STATE OF DELAWARE  
EXECUTIVE DEPARTMENT  
OFFICE OF MANAGEMENT AND BUDGET  
STATE PLANNING COORDINATION

RE: PLUS review – PLUS 2005-11-04; Nentego

Thank you for meeting with State agency planners on November 20, 2005 to discuss the proposed plans for the Nentego project to be located on the east side of Route 24, south of Route 5 in Sussex County.

According to the information received, you are seeking a rezoning from GR-1 and AR-1 to C-1 and MR/RPC for the purpose of building 373 townhouse and condominium units and an 116,000 sq. ft. shopping center on 109 acres.

**Map of Nentego with affected parcels in light blue and wellhead protection areas in dark red.**

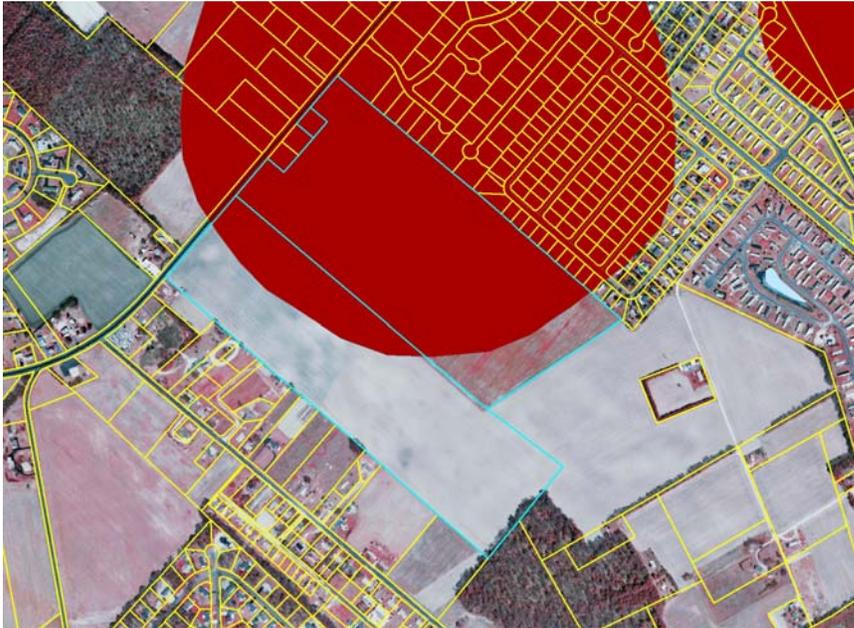
The DNREC Water Supply Section has determined that it does fall within a wellhead protection area for Tidewater Utilities (Meadows District). Most of the northern parcel and a section of the southern parcel are covered by a wellhead protection area (see following map and attached map). Wellhead protection areas are surface and subsurface areas surrounding a public water supply well where the quantity and quality of groundwater moving toward such wells may be adversely affected by land use activities.

The DNREC Water Supply Section recommends that the portion of the new development within the wellhead protection area not exceed 50% impervious cover. Further, some allowance for augmenting ground-water recharge should be considered if the impervious cover exceeds 20% but is less than 50% of that portion of the parcel within this area. The purpose of an impervious cover threshold is to minimize loss of recharge (and associated increases in storm water) and protect the quality and quantity of ground water and surface water supplies.

The proposed development would change the impervious over from 0% to approximately 24.1%. These numbers were provided by developer on the PLUS application. The development plan includes 57.65 acres of open space. Ideally, relocating open space areas to the northern parcel and the northern part of the southern parcel would decrease

the total impervious area in the wellhead protection area. Augmenting the groundwater recharge with clean rooftop run-off systems are another alternative to reducing the total impervious cover in the wellhead protection area.
